ADDENDUM NO. 3

Date February 18, 2025

Kelso School District

Coweeman Middle School Cladding Replacement

13 WEST AT ROOM D-8
R114 1/8" = 1'-0"

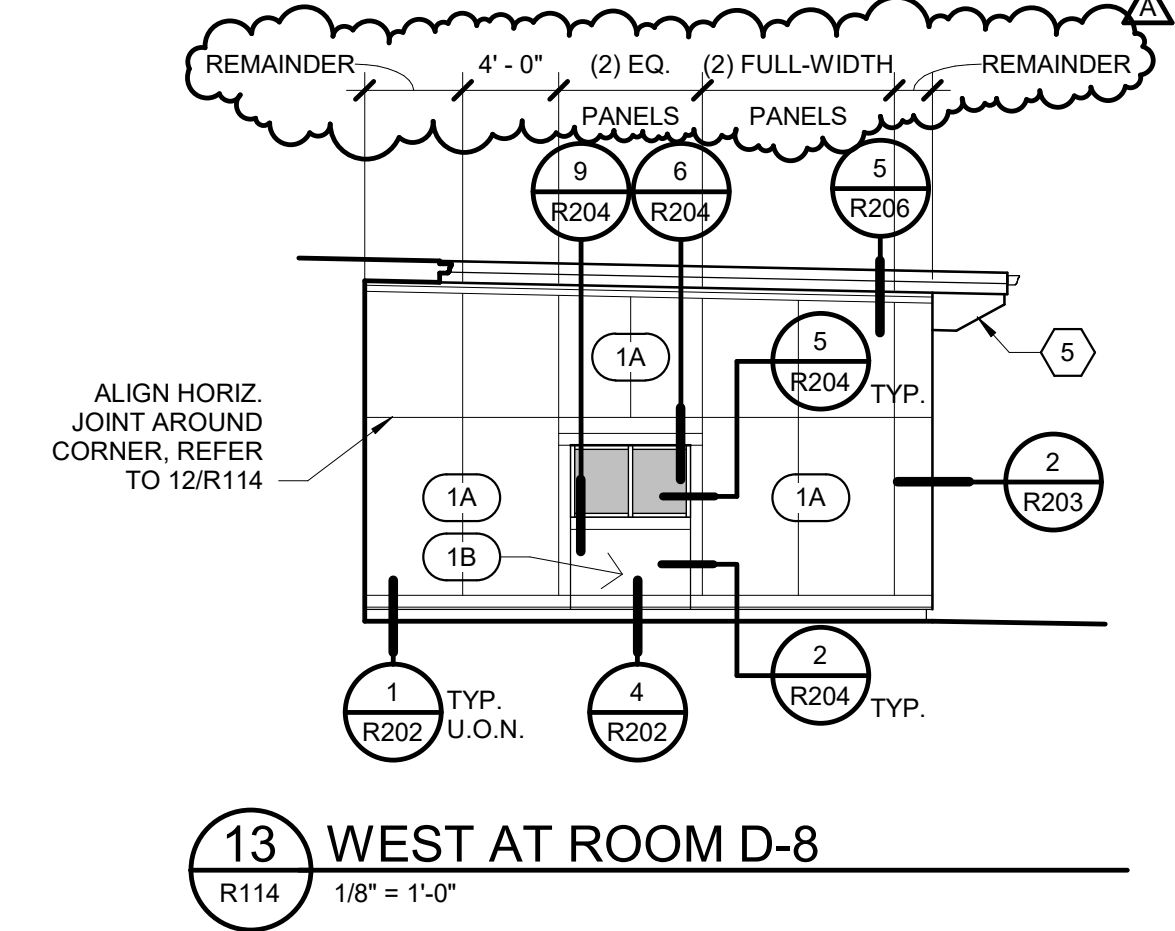
3.04	<i>Drawing Sheet R114</i>	Replace sheet with attached revised Sheet R114. Note the following changes: <ul style="list-style-type: none">• Altered layout of fiber cement panels to reduce the need for cutting panels to custom widths.• Added Addendum No. 3 revision identifier.
